RE: Agreement No. 1406
Traffic Impact Study Services
Task 222A-Liborio Commercial

Johnson, Mirmiran and Thompson (JMT) has completed the review of the Traffic Impact Study for the Liborio Commercial (a.k.a Liborio III) development, prepared by Van Cleef Engineering Associates dated October 2, 2009. This review was assigned Task Number 222A. Van Cleef Engineering Associates prepared the report in a manner generally consistent with DelDOT's *Standards and Regulations for Subdivision Streets and State Highway Access*.

LIBORIO III

TRAFFIC IMPACT STUDY REVIEW

JOHNSON, MIRMIAN & THOMPSON <i>Engineering A Brighter Future</i>		CONCEPTUAL LAYOUT FOR PROPOSED SITE ENTRANCES ON CARTER ROAD		LIBORIO III TRAFFIC IMPACT STUDY REVIEW SMYRNA, KENT COUNTY, DELAWARE	
				N.T.S	FIGURE 1
				JULY, 2010

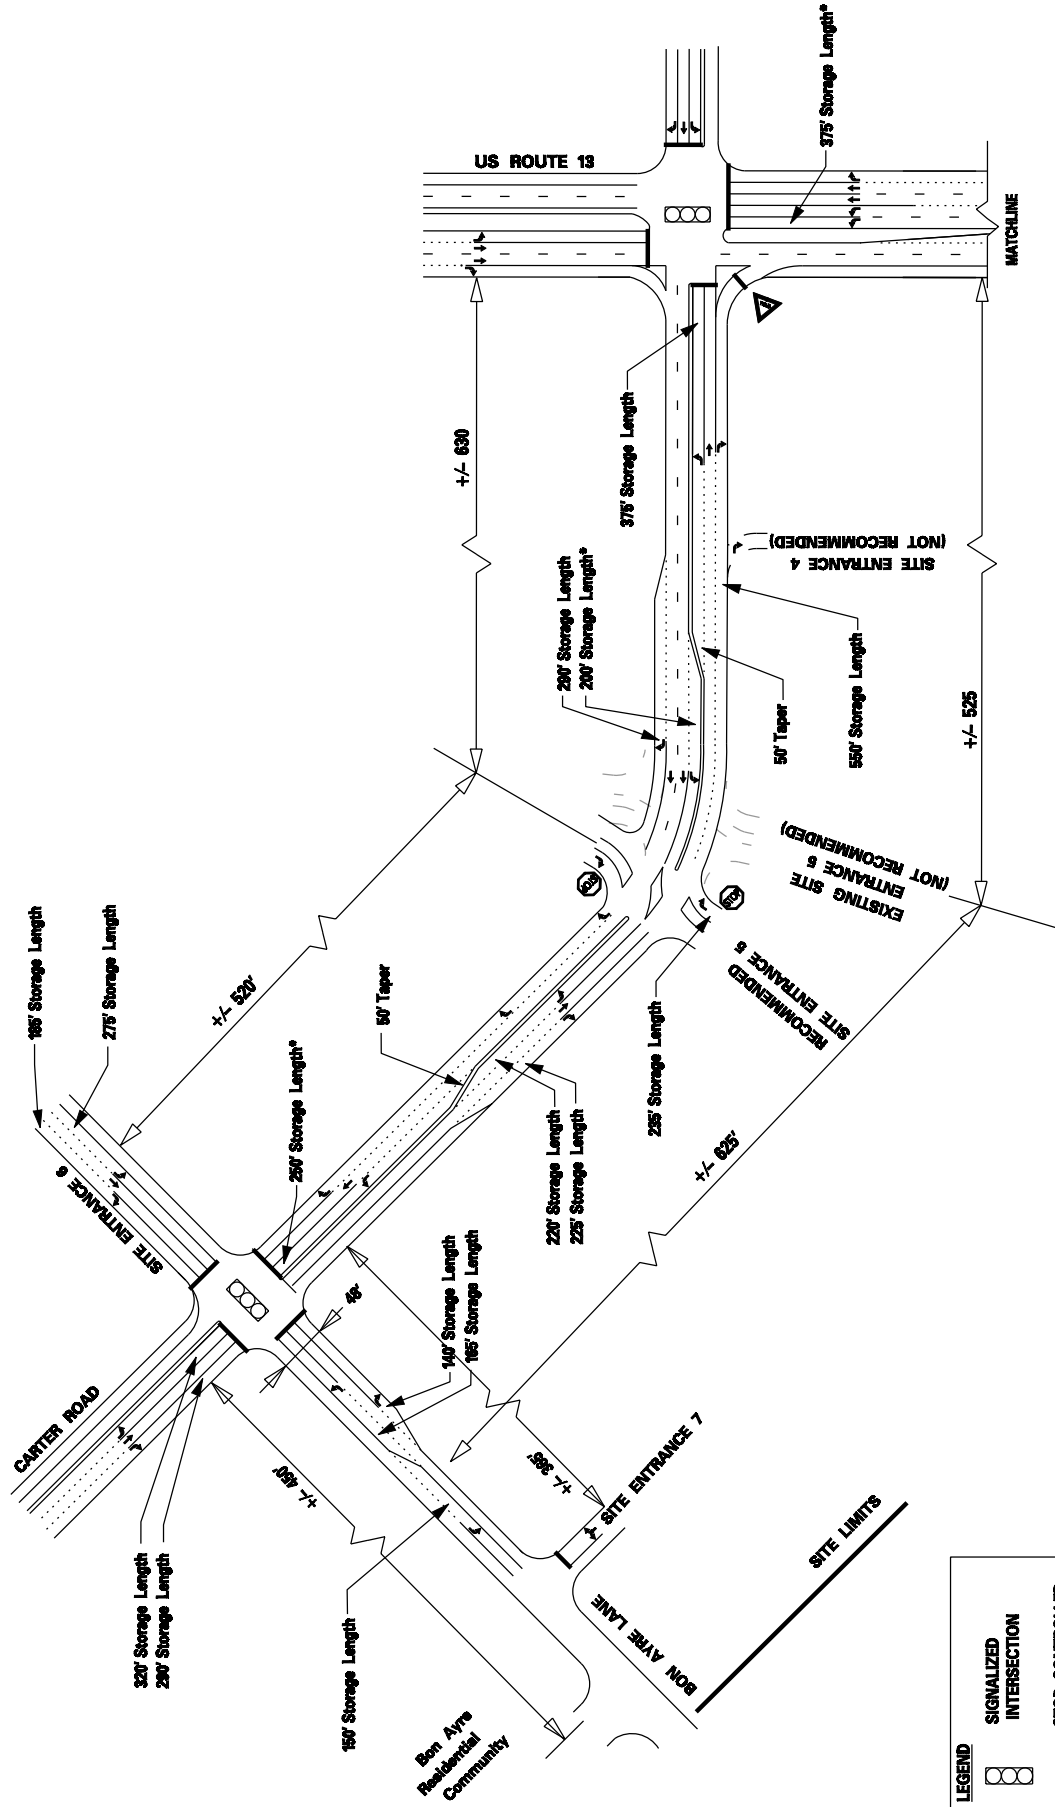
right-turn storage length of 550 feet. In addition, the proposed Site Entrance 1 across from the Gateway North Boulevard would interfere with the safety and operational efficiency of the existing acceleration lane. We recommend removing the existing acceleration lane and modifying the eastbound right-turn approach from Carter Road to a yield-control treatment. With this modification, the expected queues would extend past the proposed right-in only site entrance on Carter Road (Site Entrance 4). Hence, we do not recommend Site Entrance 4. The recommended conceptual layout for the proposed site entrances are presented in Figure 1 on page 7.

The proposed main site entrance on Carter Road (Site Entrance 5) is currently constructed and located about 525 feet west of the US Route 13 and Carter Road intersection. With the proposed yield-control treatment on the eastbound Carter Road right-turn movement at US Route 13 intersection, the required right-turn storage of 550 feet cannot be accommodated at this location. Furthermore, the eastbound left-turn lane from Carter Road onto US Route 13 is currently back-to-back with the westbound left-turn lane into the proposed site area (south). However, the expected 95th percentile left-turn queues on the eastbound left-turn lane at the intersection of US Route 13 and Carter Road require extending the storage length to about 375 feet. Due to the minimum left-turn storage length requirement at the unsignalized intersection of Carter Road and the main site entrance, two back-to-back left turns cannot be accommodated in this short distance. In order to accommodate the minimum left-turn storage lengths for the back-to-back left-turn lanes and the required right-turn storage length for the proposed yield-controlled eastbound right-turn approach at the US Route 13 and Carter Road intersection, Site Entrance 5 needs to be relocated 100 feet west of the existing location and constructed as described in Item No. 3.

3. The developer should construct a right-in/right-out/left-in site entrance (Site Entrance 5) on Carter Road approximately 630 feet west of US Route 13 and Carter Road intersection. The entrance should be consistent with the proposed lane configuration shown in the table below. This will include the construction of concrete islands with the appropriate signage at the site entrances to prevent left-turns and through movements out of the site.

LIBORIO III		
TRAFFIC IMPACT STUDY REVIEW		
SIMYRNA, KENT COUNTY, DELAWARE		
N.T.S	FIGURE 2	JULY, 2010
CONCEPTUAL LAYOUT FOR PROPOSED SITE ENTRANCES ON US ROUTE 13		
<div> <div> <div>JOHNSON, MIRMIRAN & THOMPSON</div> <div>Engineering A Brighter Future</div> </div> </div>

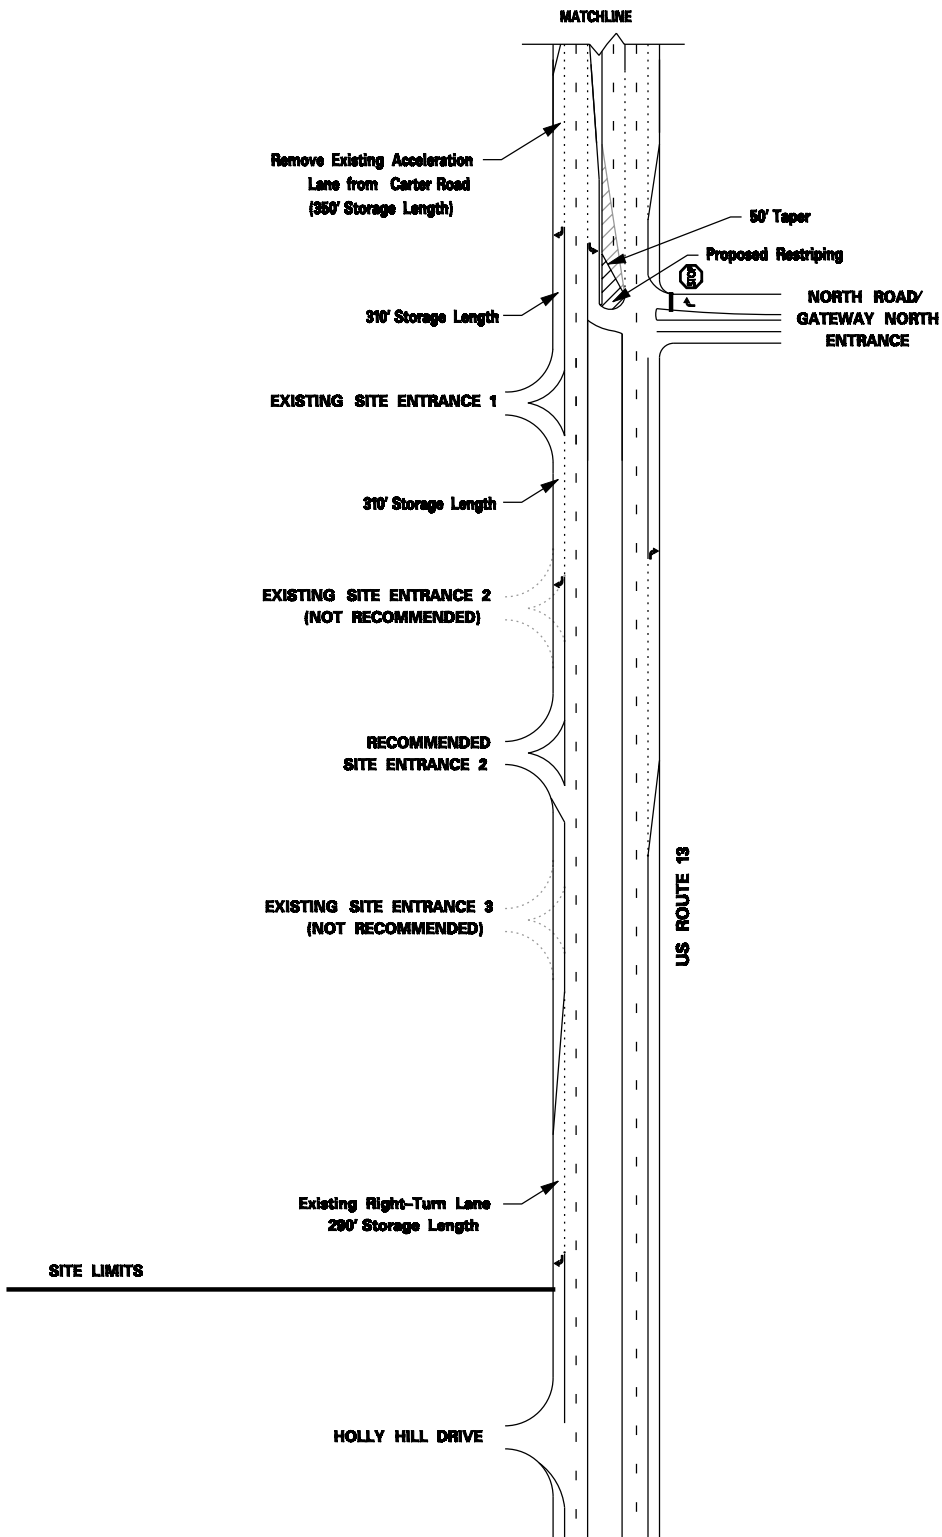
The developer is also proposing three closely spaced right-in/right-out site entrances along southbound US Route 13. With the proposed removal of the existing Carter Road right-turn acceleration lane onto southbound US Route 13, the right-in/right-out Site Entrance 1 can be accommodated as proposed with a 310 feet of storage length. However, based on DelDOT's *Standards and Regulations for Subdivision Streets and State Highway Access* manual there is not sufficient space to accommodate two additional right-in/right-out site entrances (Site Entrances 2 and 3) on southbound US Route 13. Hence, proposed Site Entrance 3 on southbound US Route 13 is not recommended. The recommended conceptual layout for the proposed site entrances on southbound US Route 13 are presented in Figure 2 on page 8.

- The developer should construct the two right-in/right-out only site entrances (Site Entrances 1 and 2) on southbound US Route 13 as shown in Figure 2. Based on DelDOT's *Standards and Regulations for Subdivision Streets and State Highway Access* manual, the recommended turn-lane lengths (excluding tapers) are 310 feet for the southbound right-turn lanes with a 50-foot right-turn radius. This work should be done in conjunction with the removal of the acceleration lane on southbound US Route 13 as described in Item No. 7 above. The developer should coordinate with DelDOT's Subdivision Section to determine the exact location of the site entrances.

FIGURE 3

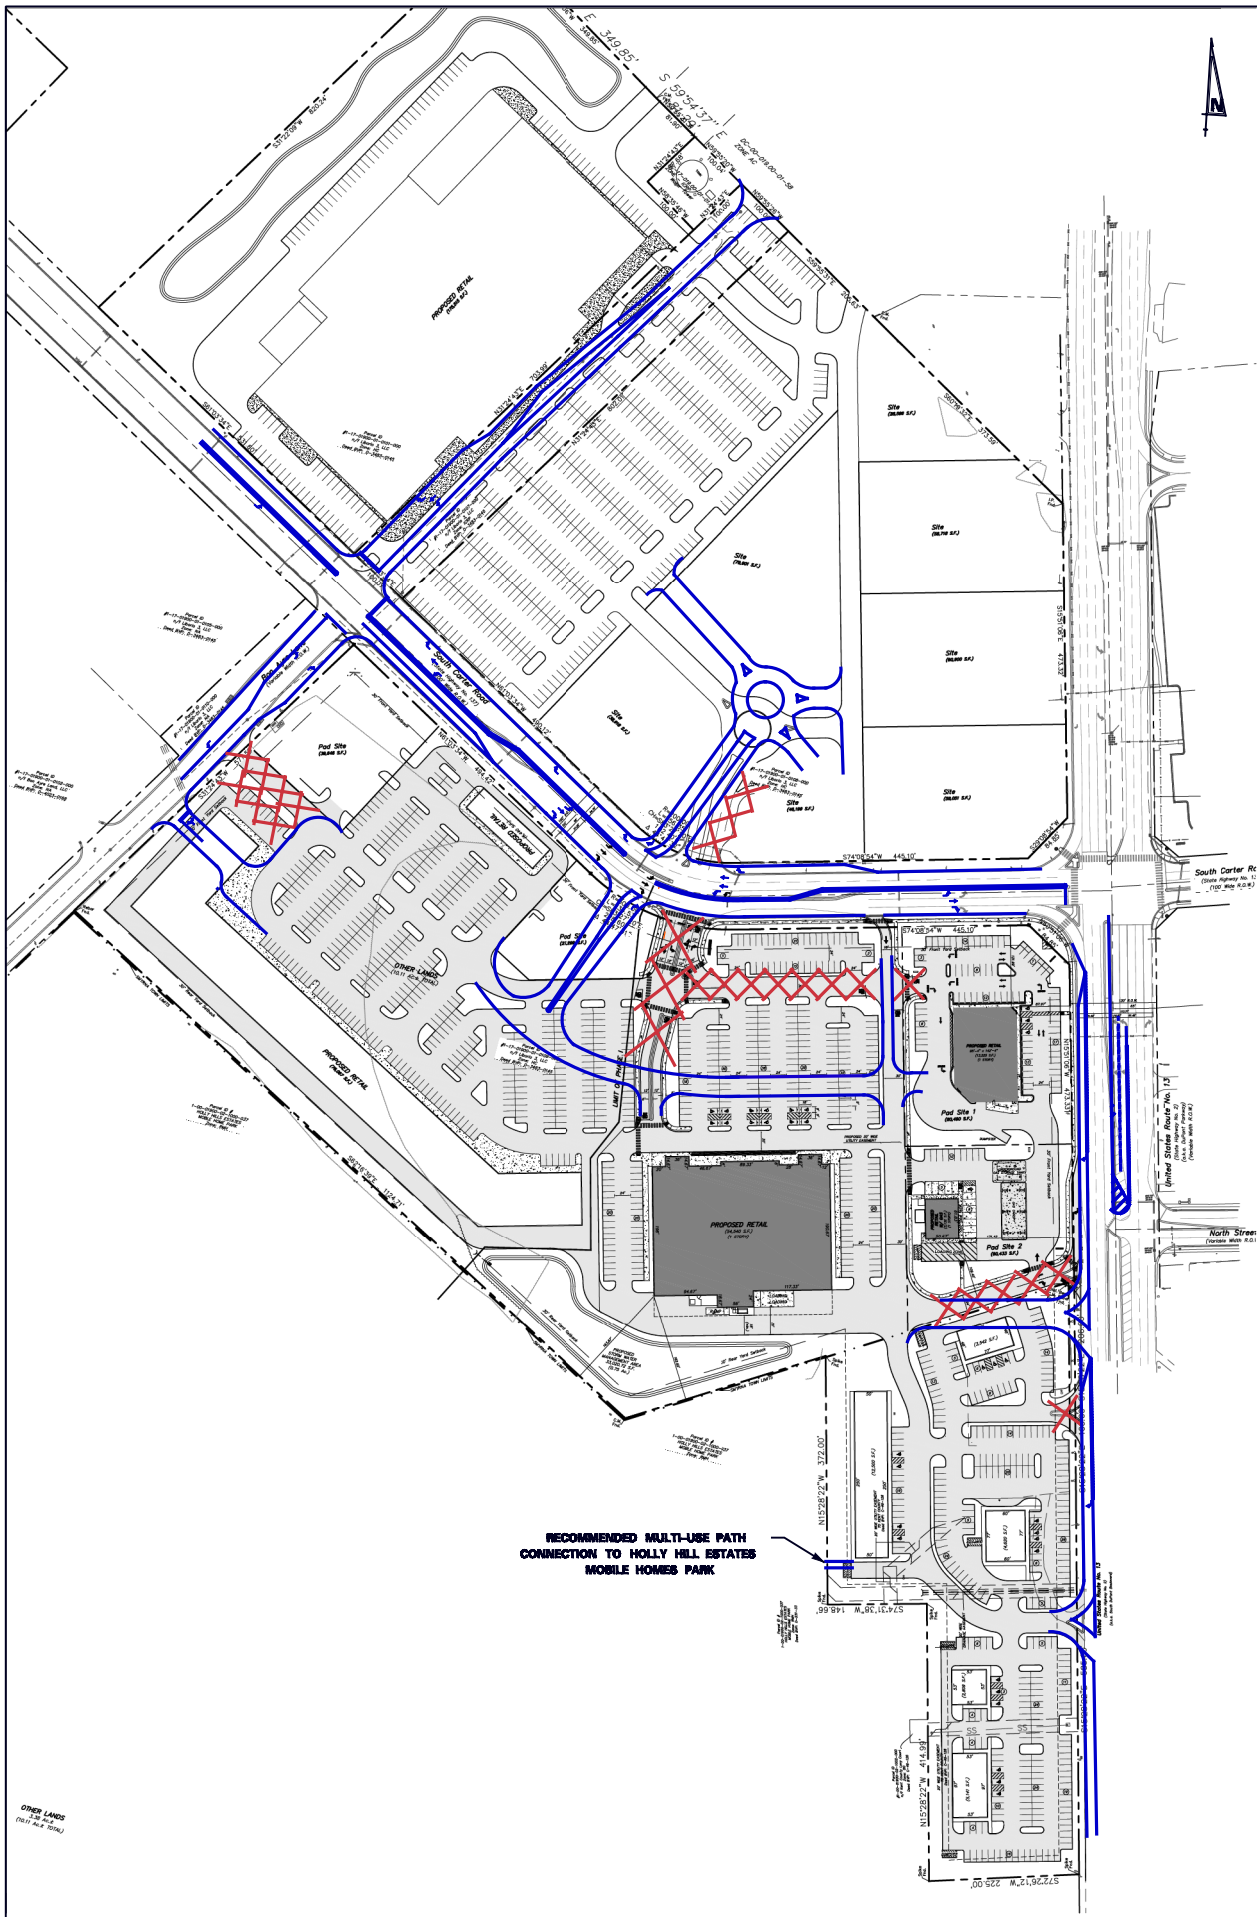
development. This improvement will require a redesign of the site plan for the northern section of the proposed development. The proposed roundabout on the northern Liborio Commercial property would need to be relocated. Some modifications to internal site roadways are also proposed to accommodate the storage requirements of the recommended entrances to the site area south of Carter Road. However, very recently after the completion of the TIS study and based on the above recommendation the developer has updated the Liborio Commercial site plan by addressing some of the comments discussed above. The updated conceptual site layout plan is shown in Figure 4 on page 15.

- i. A multi-use path connection from the site to Holly Hill Estates is recommended as shown on Figure 3.
